To: T10 Technical Committee
 From: Bob Sheffield (robert.l.sheffield@intel.com)
 Date: 12 June 2006
 Subject: 06-262r2: SAT - Example Configurations

Discussion of letter ballot comments in subclause 5.1, the Architecture Overview, led to direction to copy and modify figures from the VPD pages showing basic usage models for SAT into the Architecture Overview showing the three examples listed. This proposal shows the suggested changes, and is intended to resolve letter ballot comments in subclause 5.1 related to the example implementations.

Figure 5 — SATL contained within a SCSI target device

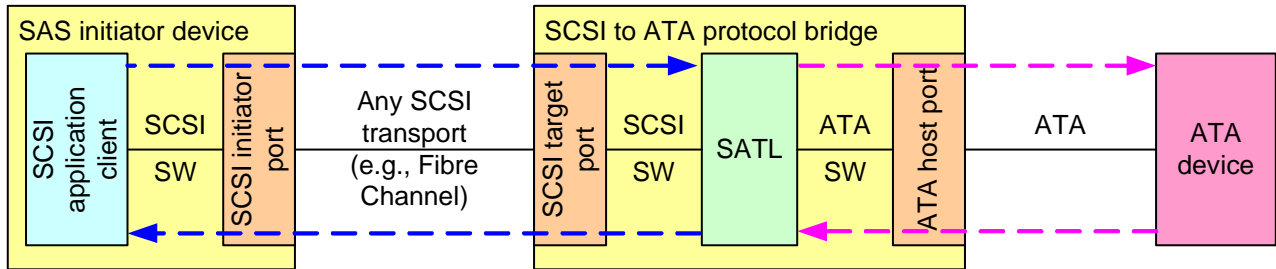
EXAMPLE 1 - Figure 5 shows a SATL contained within a SCSI target comprised of ATA devices and/or ATAPI devices using a defined SCSI transport protocol (e.g., Fibre Channel, SCSI parallel interface, or SBP-3).

Figure 6 — ATA HBA directly connected to ATA devices and/or ATAPI devices

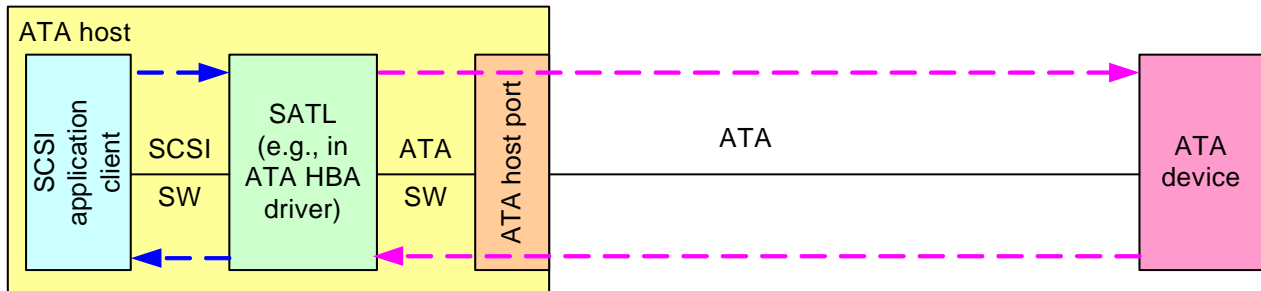
EXAMPLE 2 - Figure 6 shows an ATA Host Bus Adapter (HBA) directly connected to ATA device(s) and/or ATAPI devices, and providing SCSI transport protocol layer services to a SCSI application client in accordance with SAM-3.

Figure 7 — SAS STP initiator port connected to ATA devices and/or ATAPI devices

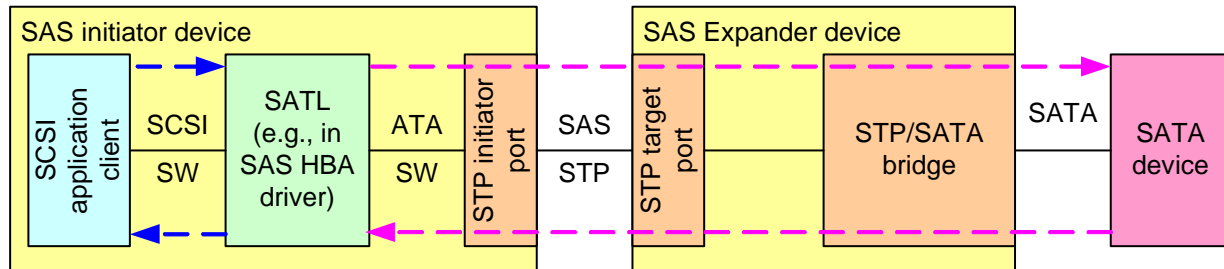
EXAMPLE 3 - Figure 7 shows a SAS STP initiator port (see SAS-1.1) connecting to ATA devices and/or ATAPI devices. The STP initiator port includes a SATL to provide the SCSI transport protocol layer services to the application client.
